This errata sheet provides updated information on known device issues affecting Cyclone® IV devices.

Table 1 lists specific Cyclone IV issues, and which Cyclone IV devices are affected by each issue.

Figure 1. Programmable PPM Detector Options in the ALTGX MegaWizard Plug-In Manager

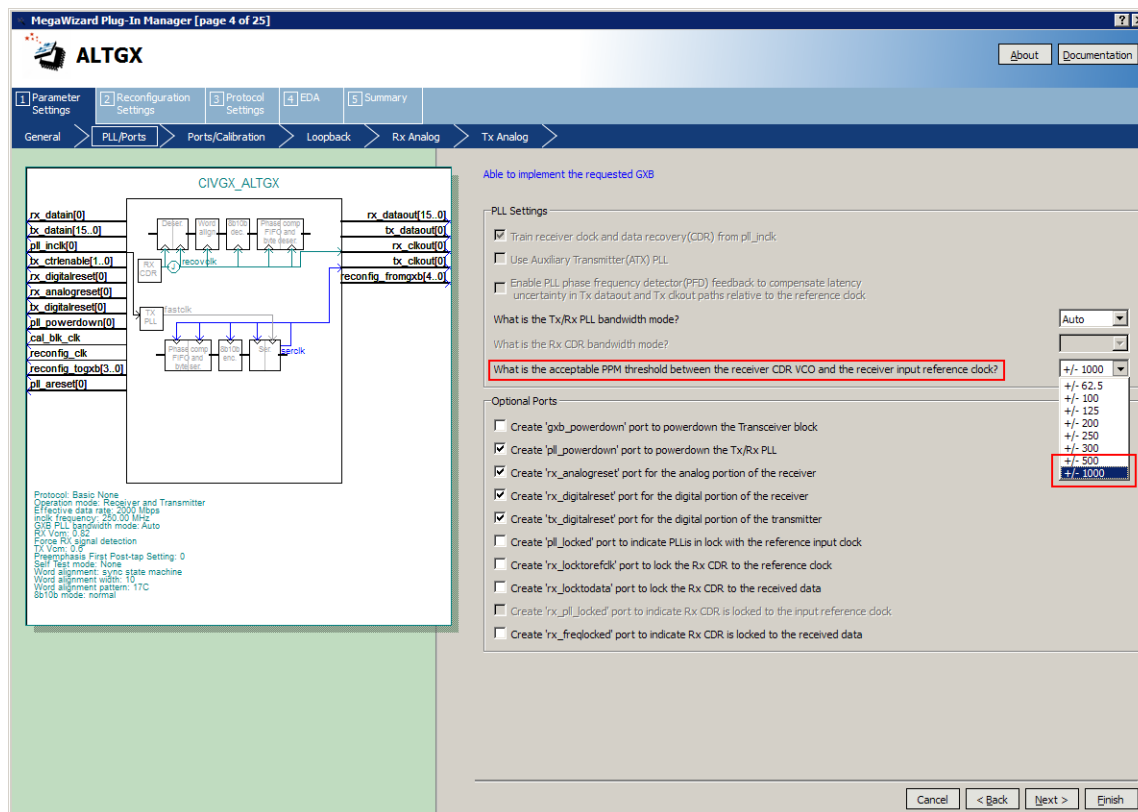
The ± 500 PPM and ± 1000 PPM options for the Programmable PPM Detector feature in the ALTGX MegaWizard™ Plug-In Manager, as shown in [Figure 1](#), are no longer supported in the Quartus II software version 10.0 SP1 and later. These options are removed because the programmed PPM threshold values exceed the receiver CDR PPM tolerance between the upstream transmitter reference clock and the local receiver reference clock.

Designs compiled with the Quartus II software version 10.0 and earlier may have a link failure risk when the receiver is operating in a system that has ± 500 PPM or ± 1000 PPM differences for the reference clock frequencies between the upstream transmitter and the local receiver. Using CDR Manual Lock mode does not overcome the link failure risk.

For a receiver design that has the ± 500 PPM or ± 1000 PPM options selected in the Programmable PPM Detector feature, Altera recommends evaluating the system operation with different options, ranging between ± 62.5 PPM and ± 300 PPM. To change the **Programmable PPM Detector** option, regenerate and recompile the ALTGX MegaWizard Plug-In Manager design file with the supported options.

If you compiled your designs using a Quartus II software version prior to 10.0 SP1, and you have selected the ± 500 PPM or the ± 1000 PPM option for the Programmable PPM Detector feature, the Quartus II Analysis and Synthesis error will be reported in the Quartus II software version 10.0 SP1 and later.
